TECHNICAL BULLETIN

[Issue No.] GOT-A-0046

[Title] Changes of the Liquid Crystal Displays and the Backlights
for GT1675M-VTBA and GT1675M-VTBD

[Relevant Models] GOT1000 Series GT1675M-VTBA, GT1675M-VTBD

■ Rating plate (GOT rear face)

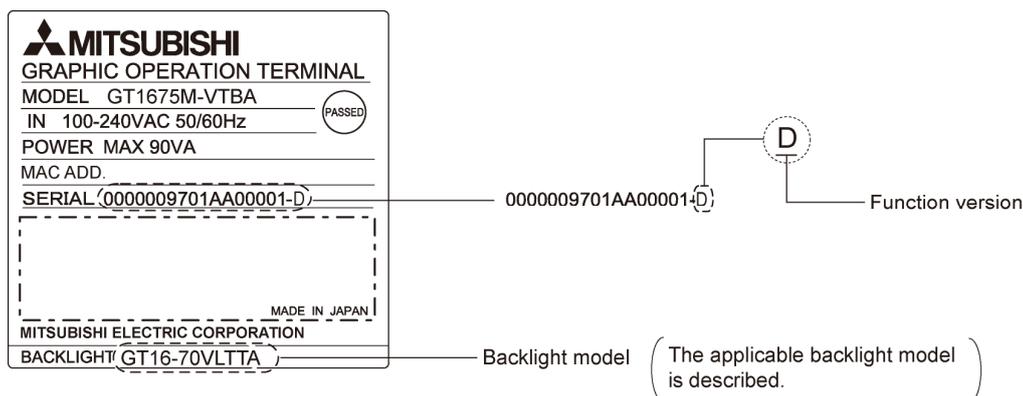
3. How to identify the GOT with a new LCD

Function version D or later applies to the GOT with a new LCD. The following shows how to check the function version.

<Indication example on the label of the packing box>

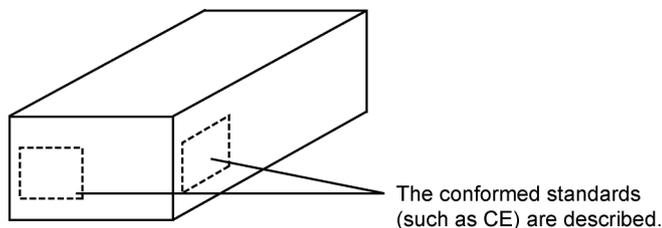
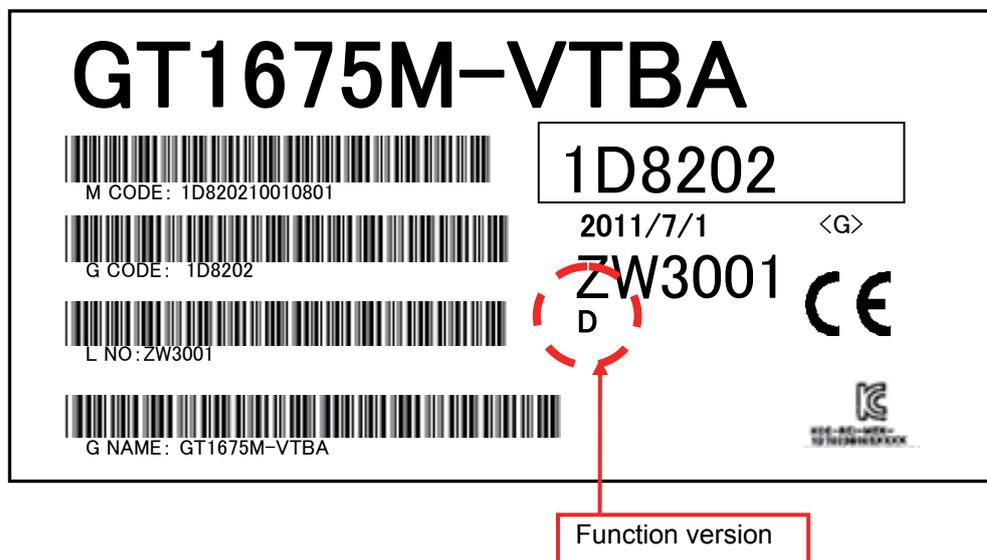
You can also check the function version with the labels on the GOT packing box. The positions of the labels differ depending on the model and the shipment date.
